Turbo HD DVR V3.5.37 build180928 Release Note (2018-7-25)

Firmware Basic Information	Firmware Version	V3.5.37 build180928
	SDK Version	V5.0 build 180718
	player	4.81mini
	Play Library (PlayCtrl.dll)	7.3.5.0
	Web version	V4.0.1 build 180623
	Web version	V2.6.5.12build20171123

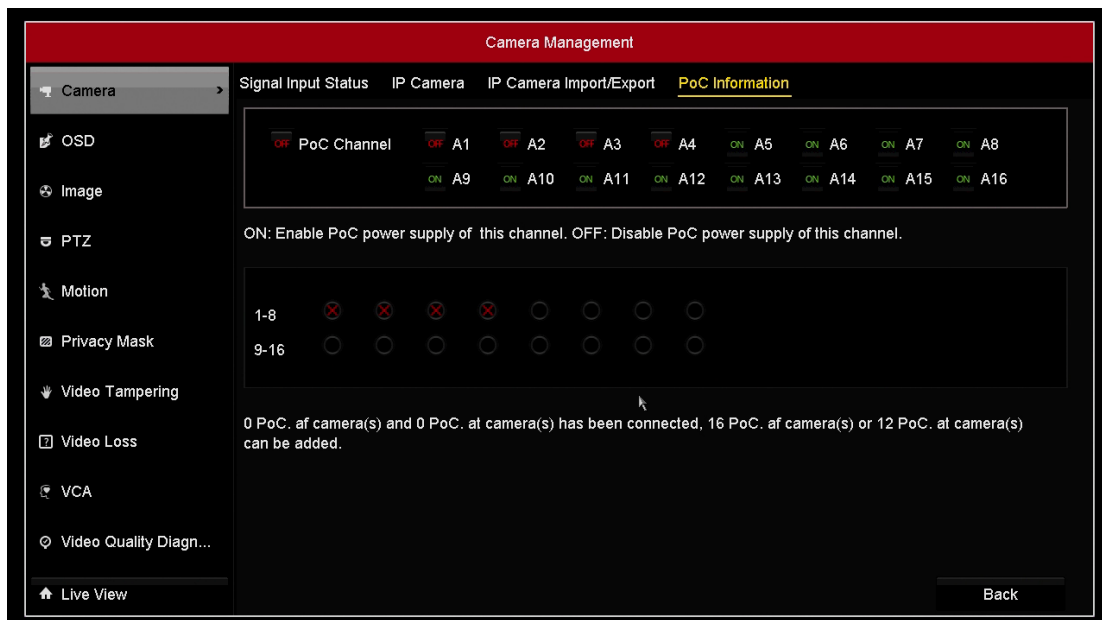
For POC models, PoC power supply could be enabled or disabled.

- i. For POC models, PoC power supply could be enabled or disabled. It's enabled as default. PoC camera can't be added to this channel when it's disabled.

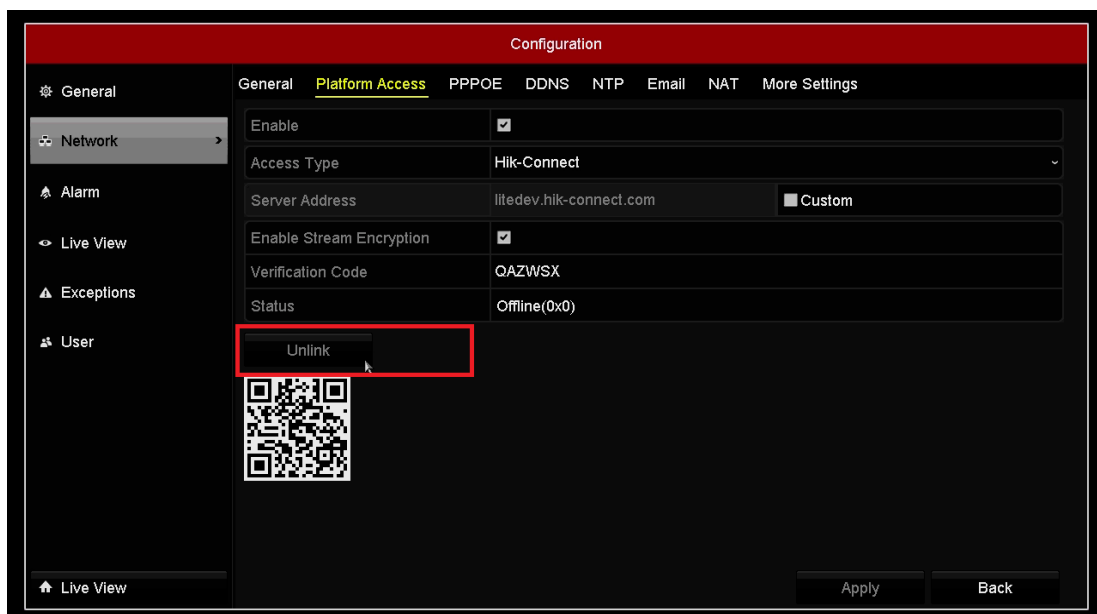
- ii. For 71/72HQ and 71/72 HU/HT series, all analog channels could be disabled for more IP channels access. It will work when enable Enhanced IP Mode except HT series (Configuration->General->More

settings->Enhanced IP Mode)

- 1) The number of IP channel which can be added to HU/HT is N as default (N represents the numebr of analog channel) ; if the analog channel is disabled, the number of IP channel will become N+N.
- 2) the number of IP channel which can be added to HQ is N/2 as default (N represents the numebr of analog channel) ; if the analog channel is disabled, the number of IP channel will become N/2+N.

Note: When enable Enhanced IP Mode ,the VCA of analog channel will be disabled and 2k/4k output will also be disabled.
